KMR.CDD.GaQ.1932.02

ORDER UNDER SECTION 96 (2) OF ACT. III OF 1901.

Sheds on plot No. 511/14 sheet No. 4.E., Garden.

AMENDED
PLAN SHOWING PROPOSED SHEDS
FOR STORAGE
ON PLOT NO. 511/14 GARDEN EAST

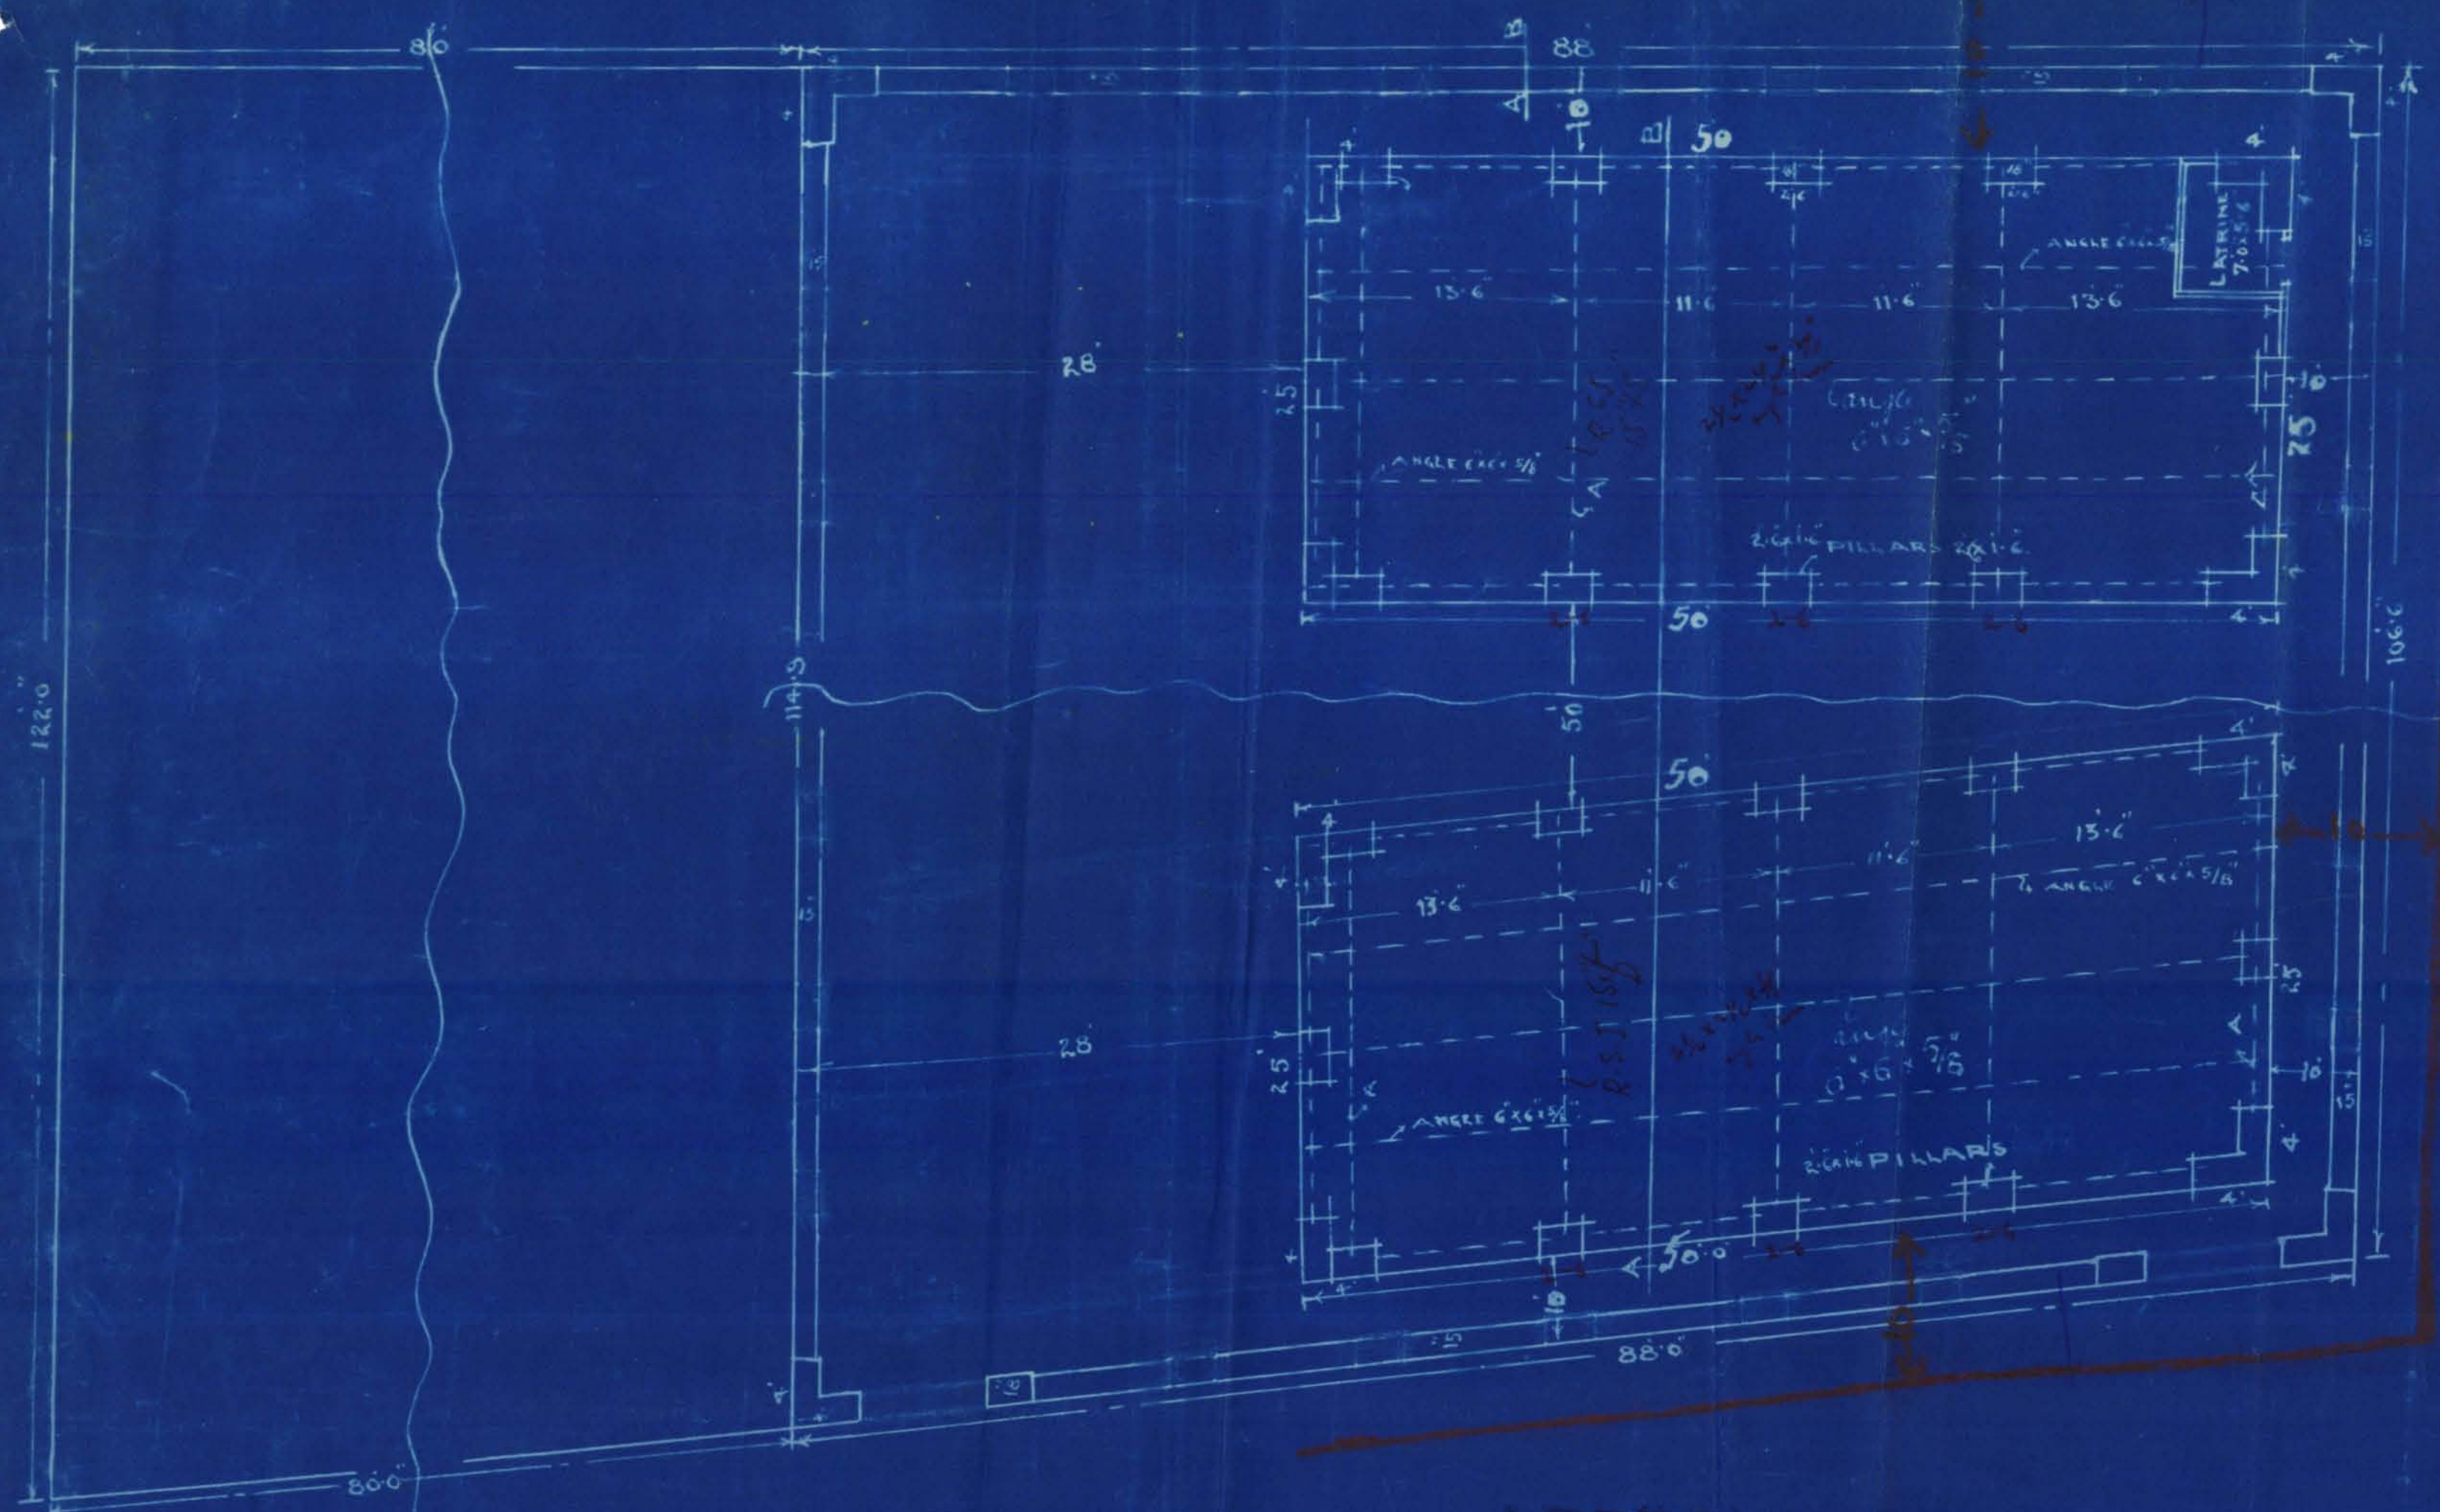
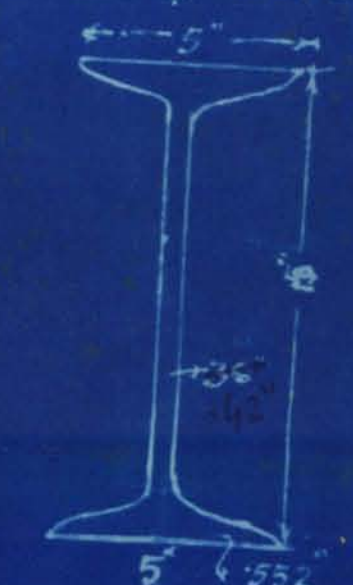
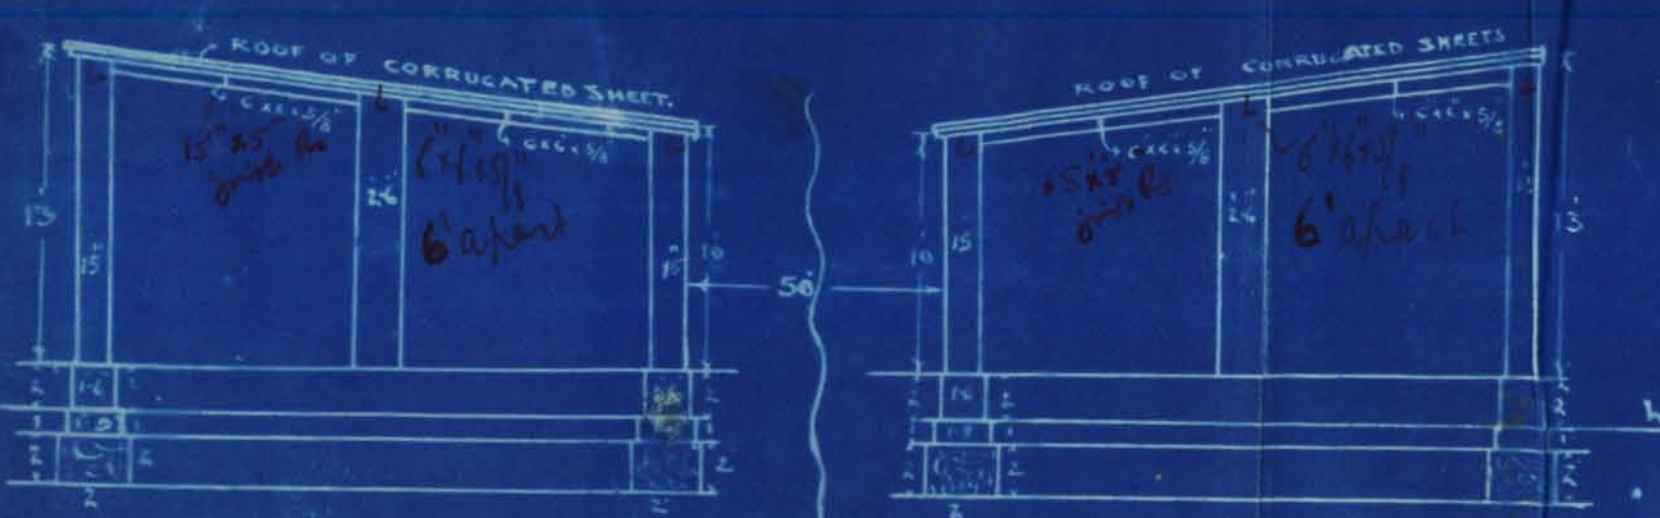
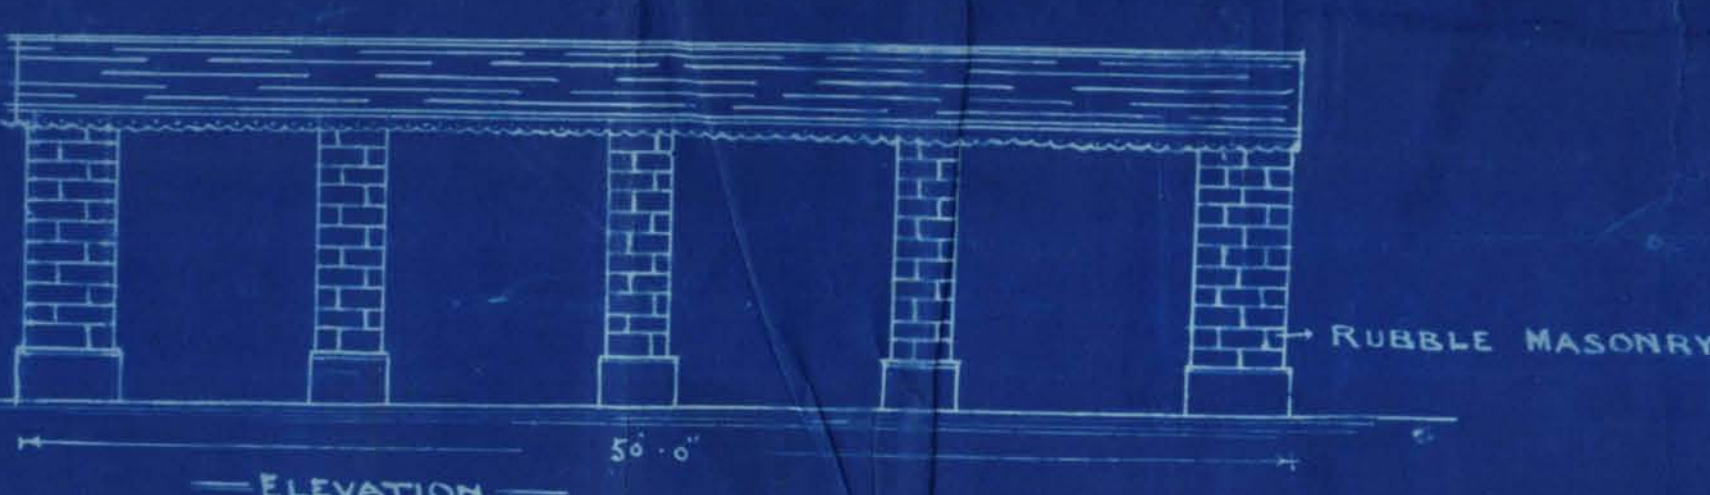
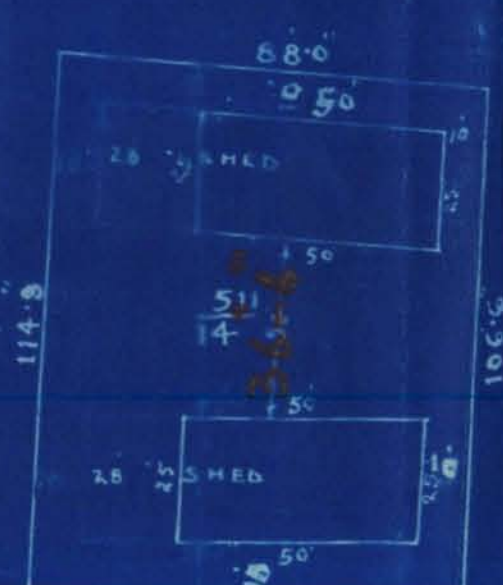
- (1) It should be specified for what purpose the sheds are required.
- (2) 10' must be left from side
- (3) Compound wall to be 5' solid and perforated above if required.
- (4)
- (5)
- (6)
- (7)
- (8)
- (9)

S. Shum. will 10' x 5' gdn
 do for 25' span?

With reference to your letter No. BSP.135/32 dated 30-4-32, I have the honour to return herewith the plans which cannot be approved as the area proposed to be built exceeds the 1/4th limit.

- (1) *Correct Plans showing the 1/4th area to be built upon must be submitted.*
- (2)

- 1) The sheds are to be used for storage purposes.
- 2). 10 feet has been left from sides.
- 3). Compound walls will be made five feet solid.

Submitted to M.O.A., the size of
 the RS beam is altered to 15' x 5'.
 There now seems to be no objection
 from structural point of view.

PLAN SHOWING PROPOSED SHEDS

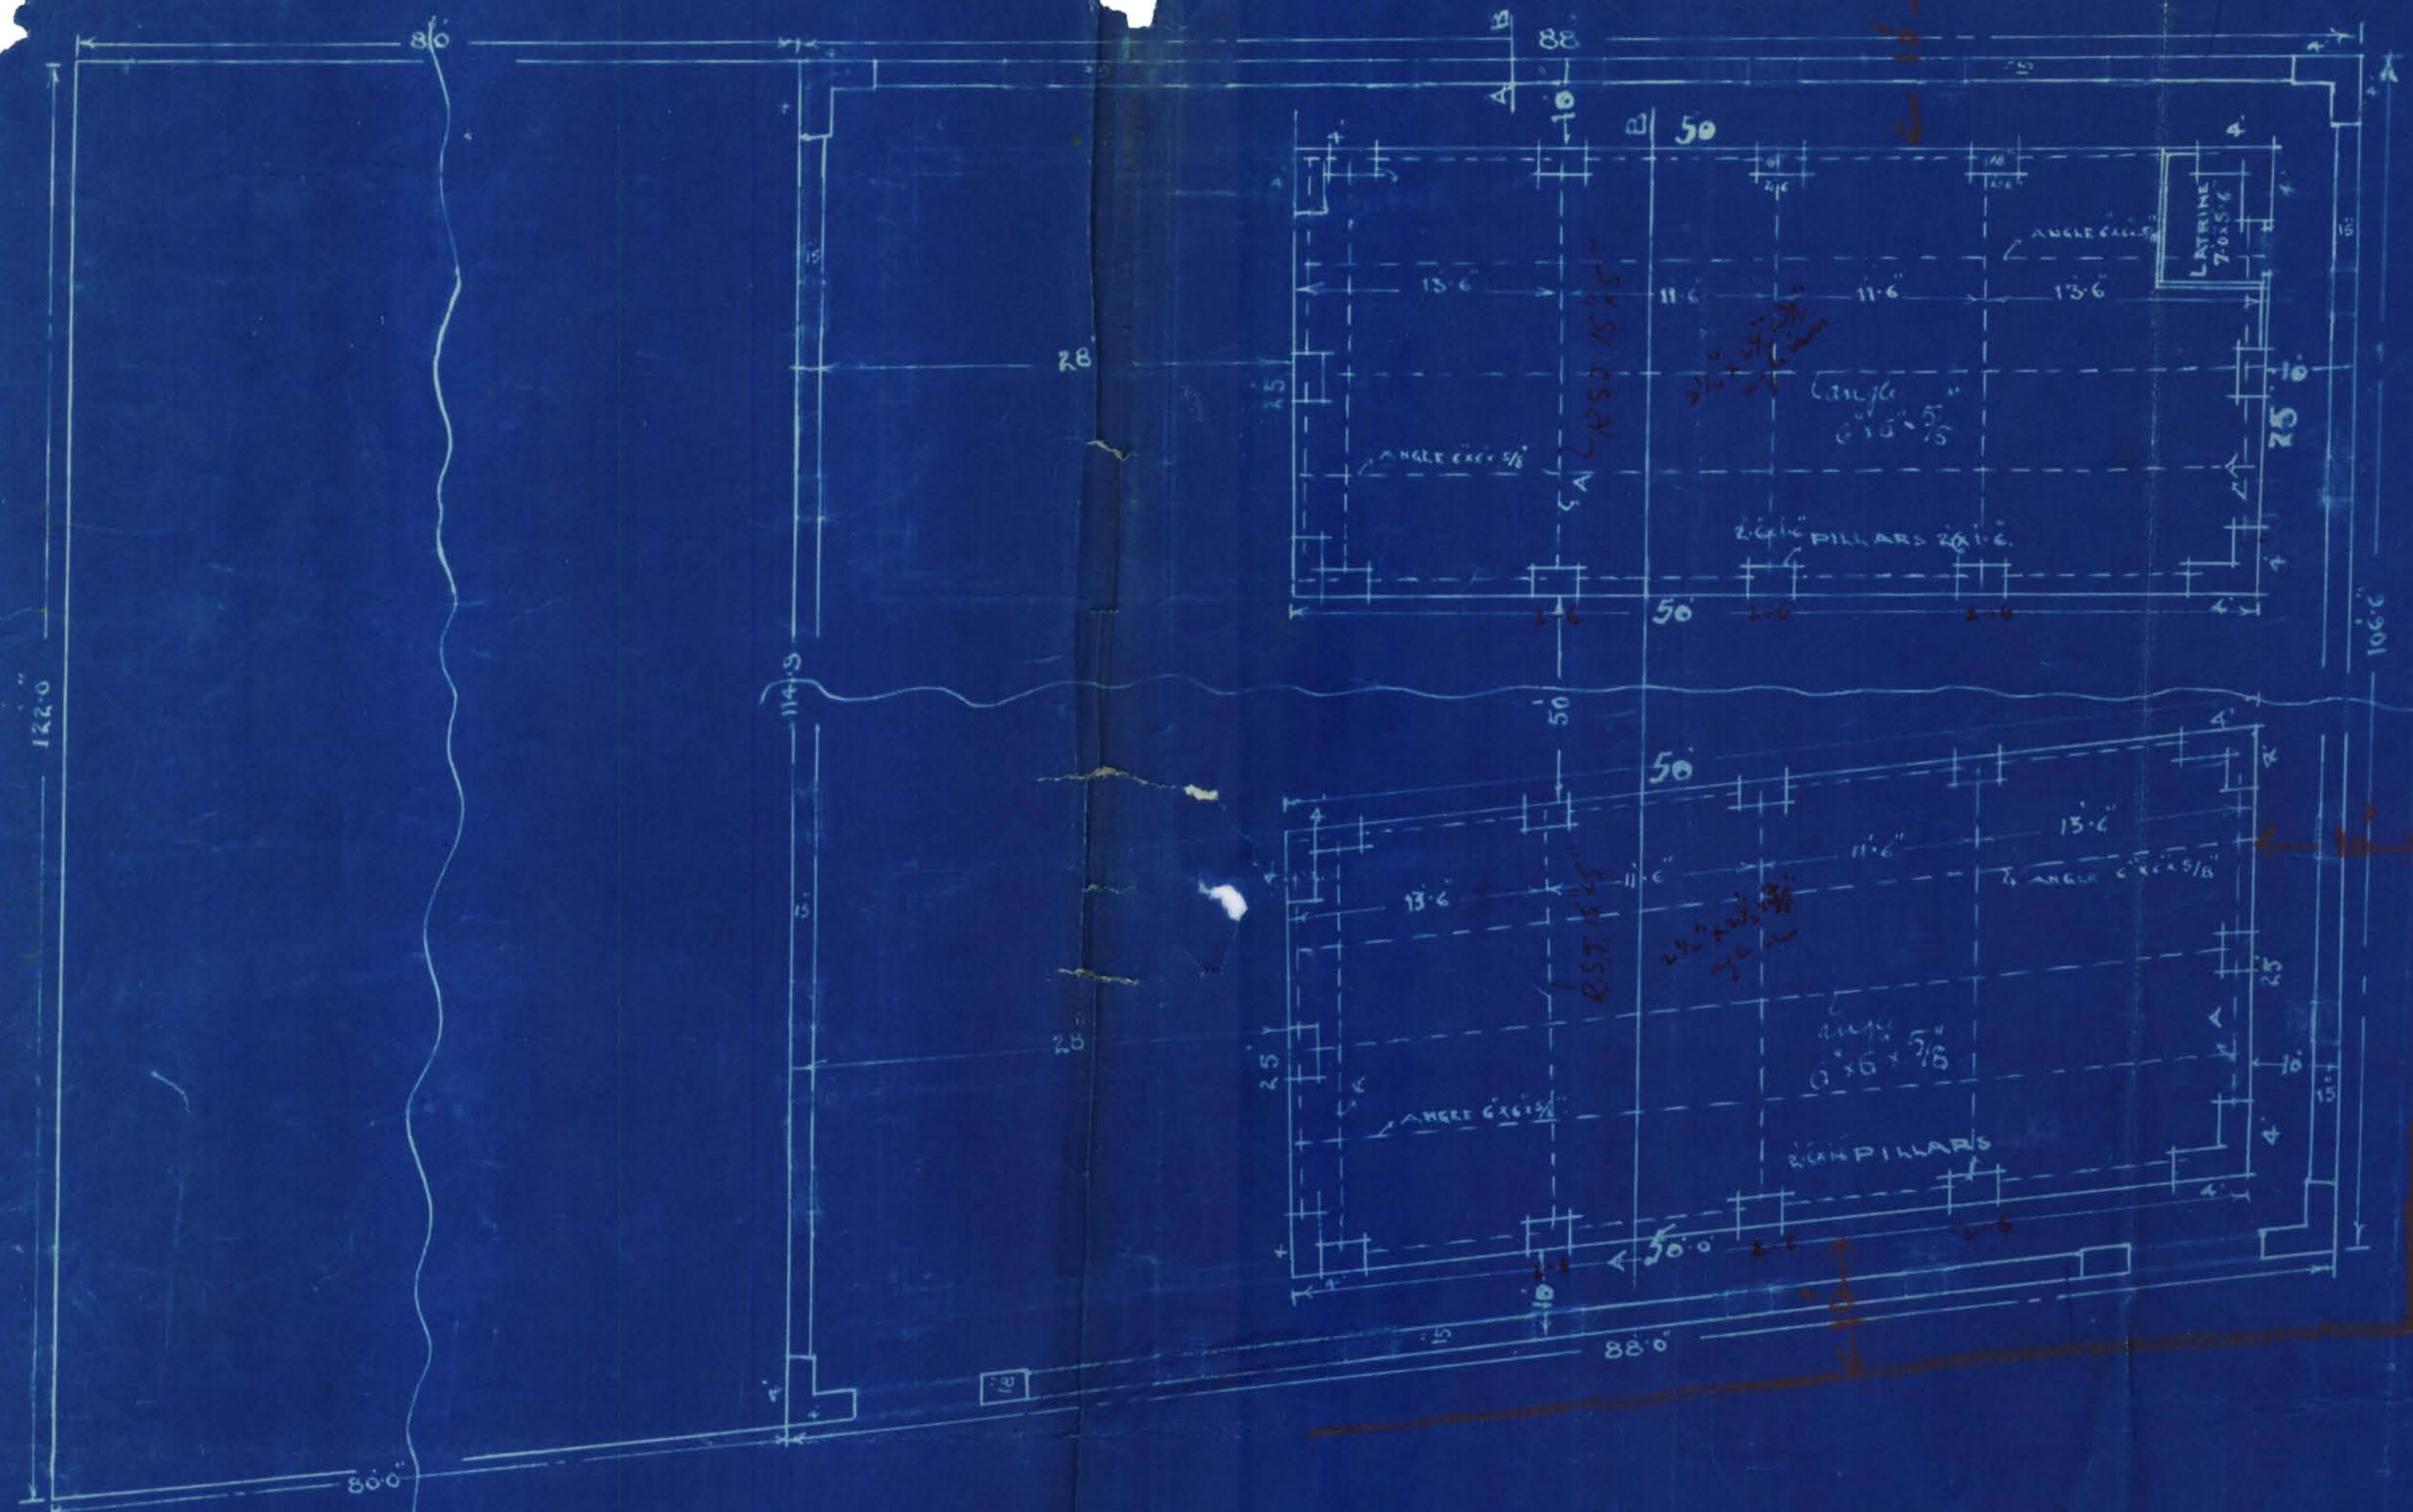
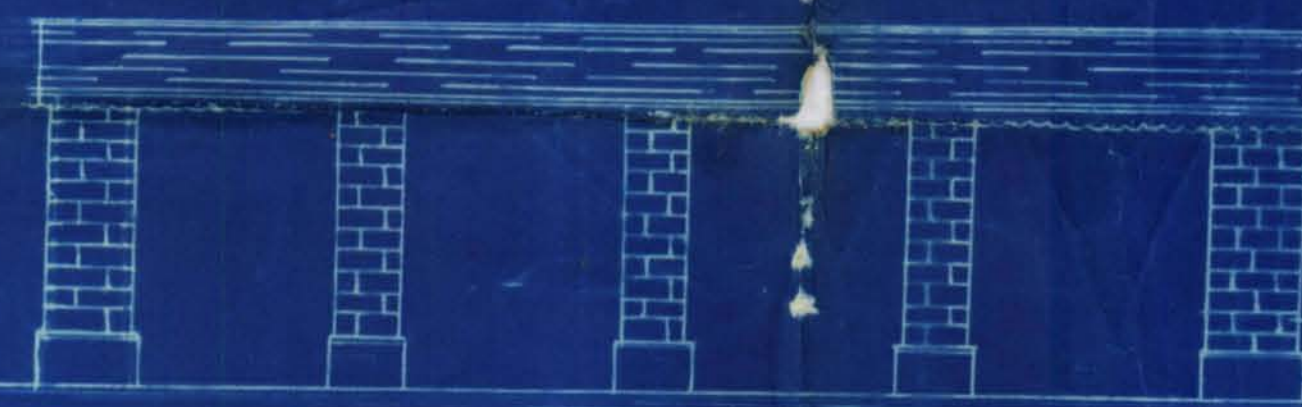
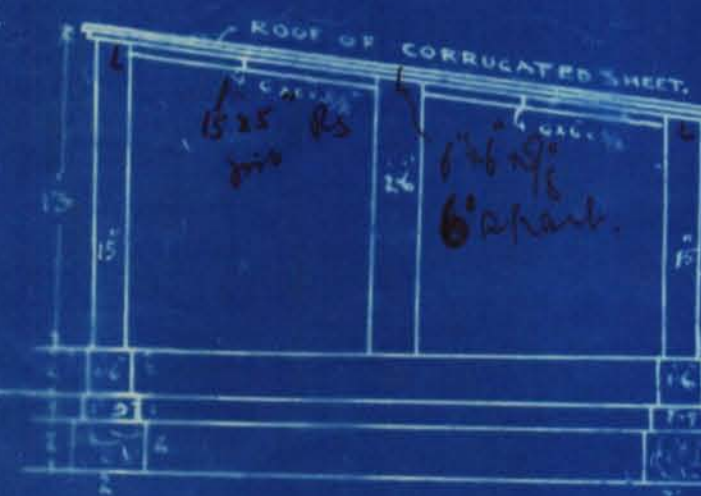
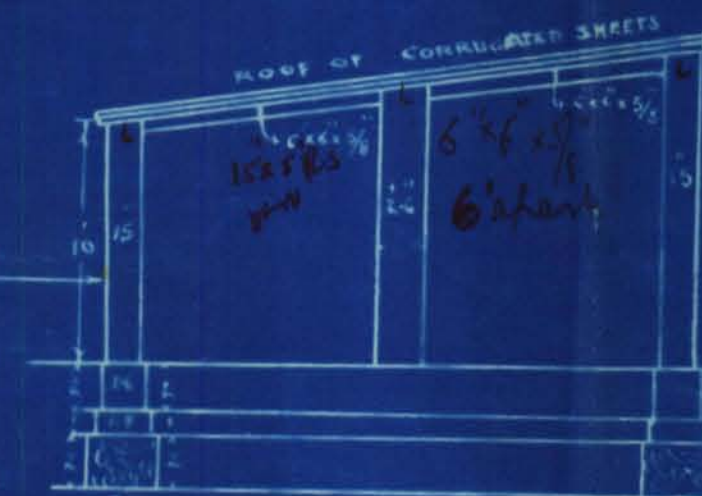
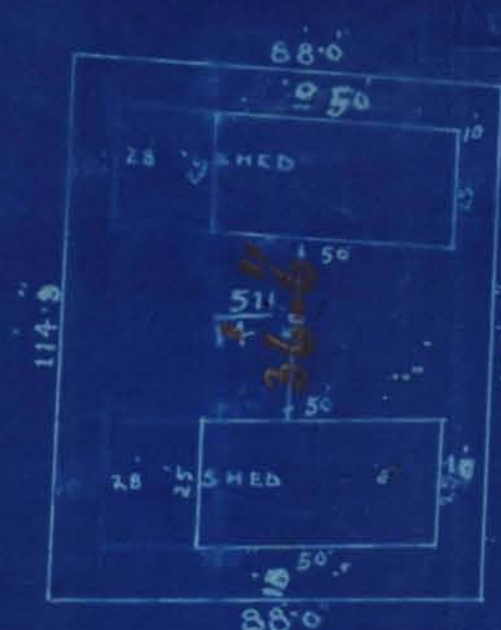
*It should be specified
what purpose is shed are
required*

✓ 6' to be built up from sides.
✓ 3' compound wall to be 5' solid and
portals above if required.
16/4
